Attachment I to IPN-88-015
Proposed Technical Specifications Related To
Movable Incore Neutron Detector Guide Thimbles

New York Power Authority
Indian Point 3 Nuclear Power Plant
Docket No. 50-286
DPR-64

Attachment II to IPN-88-015
Safety Evaluation of Proposed Technical Specification
Related to Movable Incore Neutron Detectors.

Figure 3.10-6

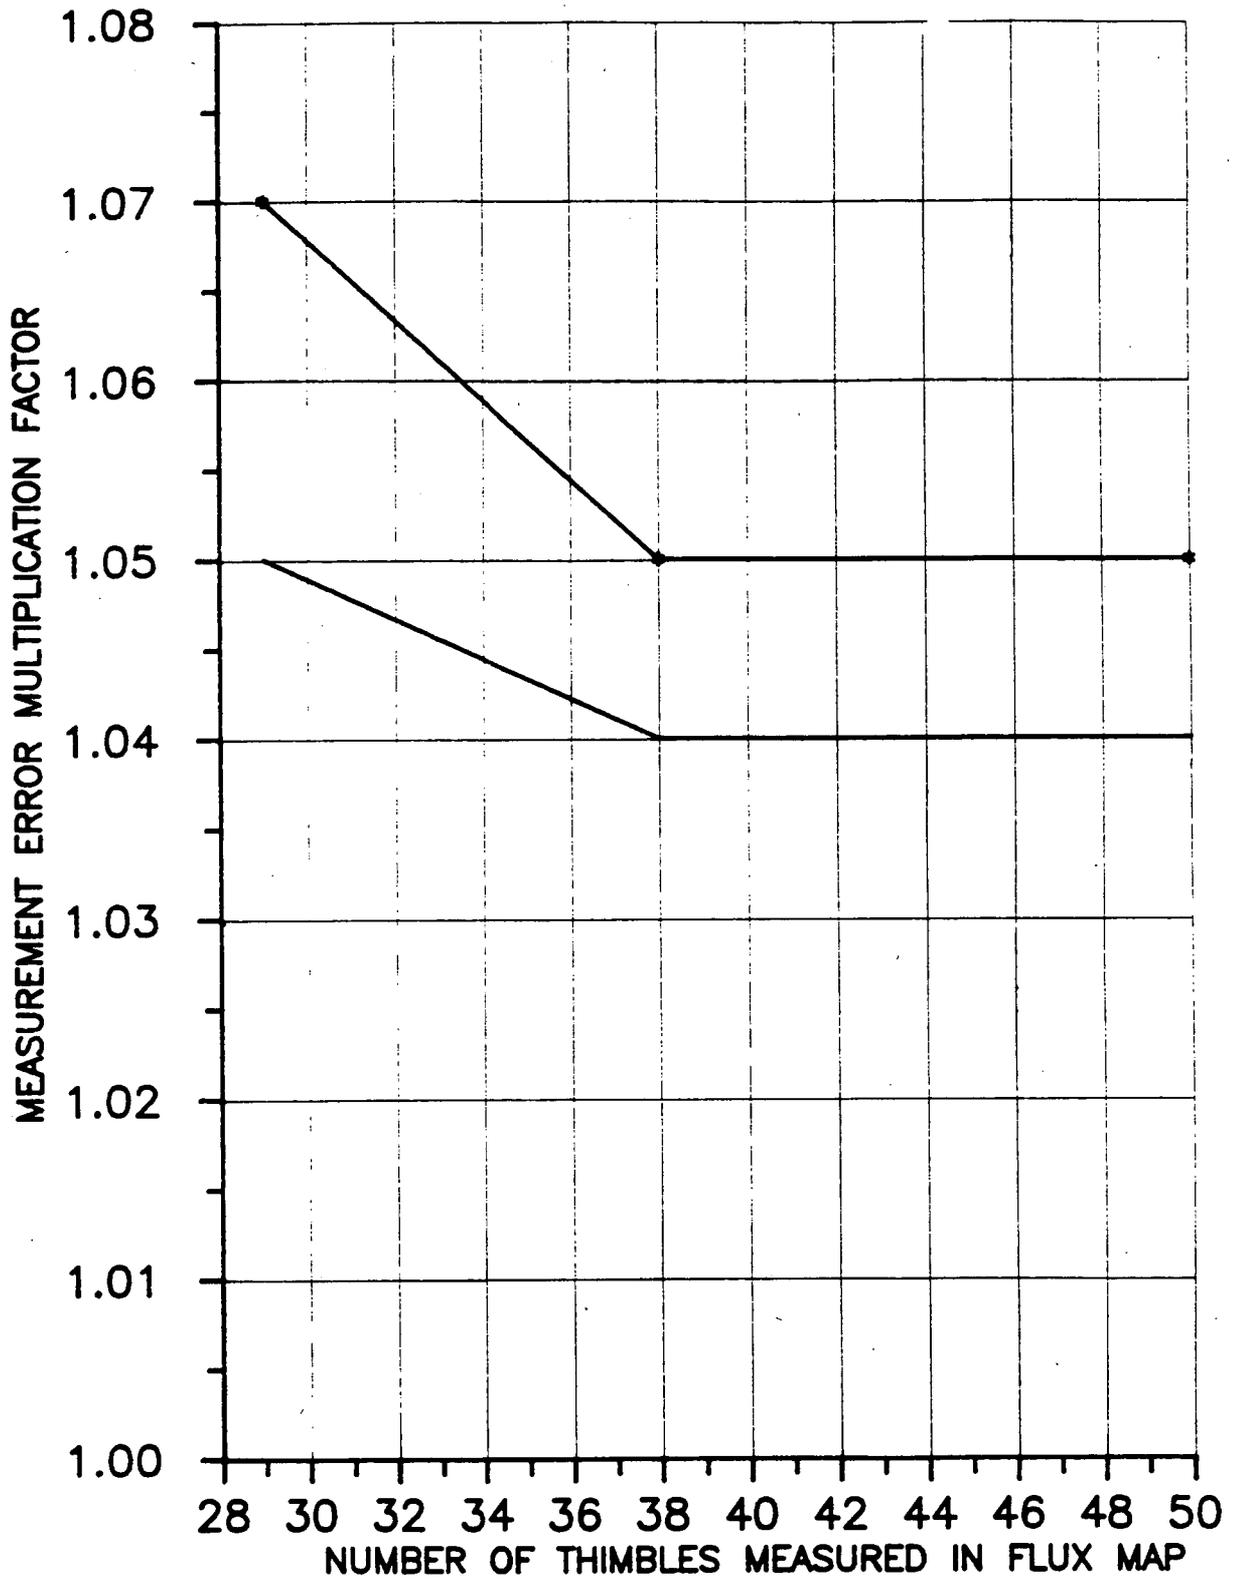
- 3.10.2.2.1 The measurement of total peaking factor F_Q^{Meas} , shall be increased by three percent to account for manufacturing tolerances and further increased by five percent to account for measurement error when 38 or more thimbles are utilized in the generation of the full core flux map. When less than 38 thimbles are utilized, the measurement error factor increases linearly from five to seven percent at 29 thimbles operable. Figure 3.10-6 provides the measurement error factor as a function of available thimbles.

- 3.10.2.2.2 The measurement of enthalpy rise hot channel factor, $F_{\Delta H}^{NH}$, shall be increased by four percent to account for measurement error when 38 or more thimbles are utilized in the generation of the full core flux map. When less than 38 thimbles are utilized, the measurement error factor increases linearly from four to five percent at 29 thimbles operable. Figure 3.10-6 provides the measurement error factor as a function of available thimbles. If either measured hot channel factor exceeds its limit specified under Item 3.10.2.1, the reactor power and high neutron flux trip setpoint shall be reduced so as not to exceed a fraction of rated power equal to the F_Q or $F_{\Delta H}^{NH}$ limit to measured value, whichever is less. If subsequent in-core mapping cannot, within a 24-hour period, demonstrate that the hot channel factors are met, the reactor shall be brought to a hot shutdown condition with return to power authorized only for the purpose of physics testing.

When an F_Q measurement is taken, both experimental error and manufacturing tolerance must be allowed for. As depicted in Figure 3.10-6, five to seven percent is the appropriate

allowance for a full core map taken with the movable incore detector flux mapping system depending on the number of thimbles utilized during the generation of the full core flux map and three percent is the appropriate allowance for manufacturing tolerance.

In the specified limit $F_{\Delta H}^{NH}$ there is an eight percent allowance for uncertainties which means that normal operation of the core is expected to result in $F_{\Delta H}^{NH}$ 1.55/1.08. The logic behind the larger uncertainty in this case is that (a) normal (e.g. rod misalignment) affect $F_{\Delta H}^{NH}$, in most cases without necessarily affecting F_Q , (b) the operator has a direct influence on F_Q through movement of rods, and can limit it to the desired value, he has no direct control over $F_{\Delta H}^{NH}$ (c) an error in the predictions for radial power shape, which may be detected during startup physics tests can be compensated for in F_Q by tighter axial control, but compensation for $F_{\Delta H}^{NH}$ is less readily available. When a measurement of $F_{\Delta H}^{NH}$ is taken, experimental error must be allowed for and 4 percent is the appropriate allowance for a full core map taken with the movable incore detector flux mapping system with 38 or more thimbles available. As shown in Figure 3.10-6, the measurement allowances will be linearly increased from 4 percent to 5 percent at 29 thimbles available.

Section 3.10 of Appendix A to the Operating License is being revised to increase the measurement inaccuracy to be applied to the hot channel factors prior to the comparison to the applicable Technical Specification limits. This increase in the hot channel factors measurement inaccuracy will compensate for the measurement inaccuracy posed by the reduction in the number of operable thimbles from 38 to 29 thimbles.

A representative flux map for Indian Point 3 was evaluated assuming 5 different random thimble deletions so that only 29 thimbles were available. The results based on the 29 thimble maps were compared to the values based on the reference map. The mean change in F_Q with 29 thimbles available was found to be 0.3692%. The mean change in $F_{\Delta H}$ was found to be -0.3747%. In order to compensate for this additional measurement inaccuracy, the total measurement inaccuracy factor, which is applied to the measured hot channel factor prior to comparison to the Technical Specification limit, will be increased by 1.0% for $F_{\Delta H}$ and 2.0% for F_Q when only 29 thimbles are available. This additional inaccuracy factor linearly increases from 0% with 38 or more thimbles available to 1.0% for $F_{\Delta H}$ and 2.0% for F_Q , with 29 thimbles available.
